memorandum

TO	Jo Young	FROM	Parviz Namjou
	Stevenson Aggregates Ltd	DATE	5 September 2025
RE	Drury Quarry – Sutton Block Expansion, Auckland Council Further Information Request on Groundwater

Below is additional information in response to Earthtech's (Auckland Council's Groundwater consultant) second s67 queries dated 22 August 2025 regarding the proposed Drury Quarry – Sutton Block Expansion application.

Figure 1: Distance Drawdown Plot for Stage 5

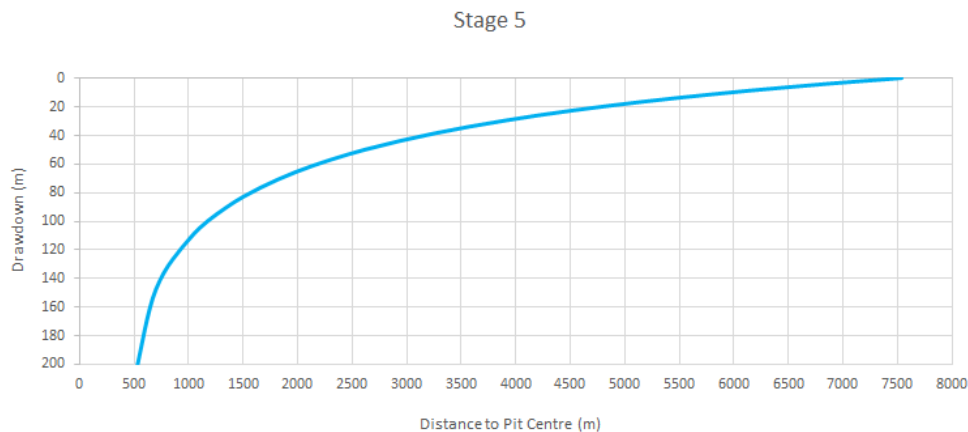
Proposed monitoring of shallow and deep groundwater levels to the east of the Sutton Block expansion within the predicted 7.5km zone of dewatering influence. Listing of groundwater monitoring bores in draft consent conditions.

The distance drawdown plots for the Sutton Block quarry stages (Stages 2 to 5) are presented in the Groundwater and Surface Water Effects Assessment (Technical Report L) (PDP 2025). The predicted drawdown in all farm wells within the zone of influence is presented in Appendix H: Predicted Drawdowns in Farm Wells East of Huna Fault (Stages 2 to 5) (PDP 2025). The methodology is based on the assumption of the uniform aquifer conditions using analytical methods. The distance drawdown plot for Stage 5 is shown in Figure 1 below.

Based on the distance drawdown plot for Stage 5 and predicted drawdowns for Stage 5 for each bore within the zone of influence (as presented in Appendix H, PDP 2025), it is possible to generate the drawdown contour map. However, the Hunua and Drury Quarries monitoring data have shown that the actual groundwater drawdowns in the greywacke do not follow the predicted drawdown contour presented in PDP 2011 and PDP 2012, and only on-going monitoring can accurately identify the drawdown pattern. This is because any sub-surface fracture zones can alter the groundwater drawdown contours.

Figure 2: Hunua Quarry Monitoring Bores close to the Northern Zone of Influence Boundary

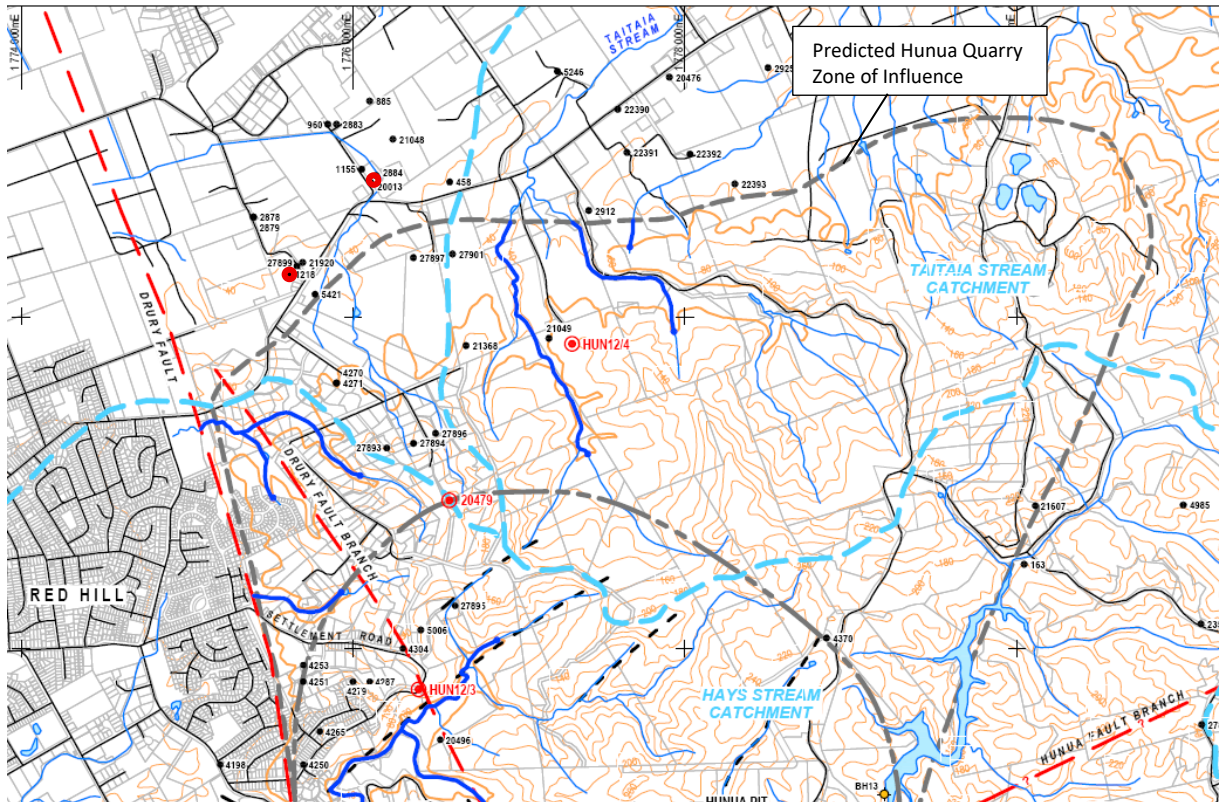
Earthtech's (2025) has also stated that the Hunua Quarry zone of dewatering extending beyond the northern edge to outside of the 7.5km Sutton Block zone of dewatering influence. Therefore, cumulative drawdown effects from the Hunua Quarry need to be considered for the Sutton Block application.

Ongoing monitoring for the Hunua Quarry occurs in bores HUN12/4, 1218, and 20013, which were drilled down to RL-5m, RL-51m and RL-149.7m respectively in the greywacke close to the northern boundary of the Hunua Quarry zone of influence (Figure 2). This monitoring has shown no drawdown effects as a result of the Hunua Quarry dewatering down to RL20m (note that HUN12/4L is located 800m inside the zone of influence). The new Symonds Hill Pit will be dewatered down to RL-5m (25m more than the previous pit),

but about 1km further away from the northern zone of influence boundary. The lack of any response in the above bores, considering the flat hydraulic gradient, indicates that the northern boundary of the zone of influence for the Hunua Quarry is much closer to the Hunua sump than initially assessed. It is not likely that the northern Hunua Quarry boundary of the zone of influence exceeds the conservative zone of influence predicted for the Sutton Block. Therefore, no interference effects are likely beyond the 7.7km Sutton Block zone of influence. Even if HUN12/4 responds in future to the Symonds Hill Pit, the dominant flow for Sutton Block Stage 5 will be towards the lowest pit (i.e., Sutton Block) due to relatively flat hydraulic gradient in the Hunua greywacke block. This aligns with the conceptual model (PDP 2024).
